Access Compliance Report Public Rights-of-Way (Curb Ramps)

Main Street: DAWNWOOD Cross Street: ALGERWOOD Location: SE

ADA ID: RPRK211025120729 Ramp Type: Type 4 - Parallel Initial Pass/Fail: Fail Overall Compliance: No Severity Score: 20

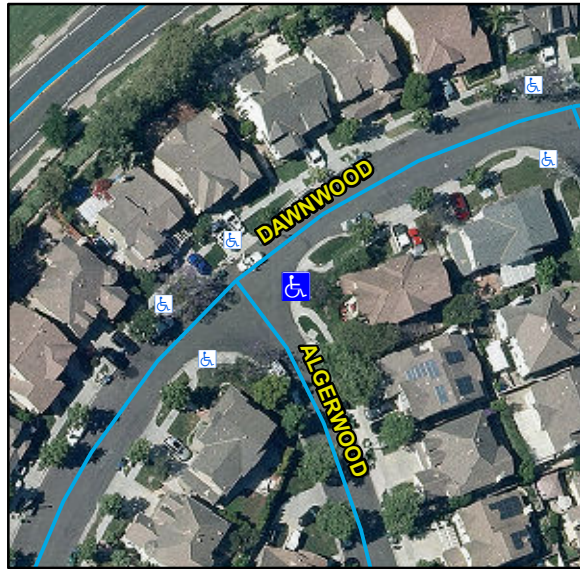
R204.3, R304.5.1, R304.3.2, R304.5.3, STD 1115

Compliance	Description	Data	Compliance	Description	Data
N/A	Ramp Length LT (in)	109	N/A	Ramp Length RT (in)	117
No	Ramp Width LT (in)	47	No	Ramp Width RT (in)	47
No	Ramp Run Slope LT (%)	8.8	Yes	Ramp Run Slope RT (%)	5.1
No	Ramp Cross Slope LT (%)	3.8	No	Ramp Cross Slope RT (%)	2.4
N/A	Landing Present	N/A	N/A	DWS Provided	N/A
N/A	Landing Length (in)	N/A	N/A	DWS Contrast	N/A
N/A	Landing Width (in)	N/A	N/A	DWS Length (in)	N/A
N/A	Landing Run Slope (%)	N/A	N/A	DWS Full Width	N/A
N/A	Landing Cross Slope (%)	N/A		DWS Offset Type	N/A
N/A	Landing Movement Obstructed?	N/A	N/A	DWS Offset Left (in)	N/A
	Landing Movement Type	N/A	N/A	DWS Offset Right (in)	N/A
N/A	Landing Shared	N/A			
N/A	Clear Space	Yes			
N/A	Clear Space To Crosswalk (in)	N/A			
N/A	Marked Crosswalk 1	No	N/A	Marked Crosswalk 2	No
	Crossing 1 Direction	NW		Crossing 2 Direction	SW
	Marked Crosswalk 1 Width (in)	N/A		Marked Crosswalk 2 Width (in)	N/A

Remove & Replace Curb Ramp With Two New Directional Ramps or Equivalent.
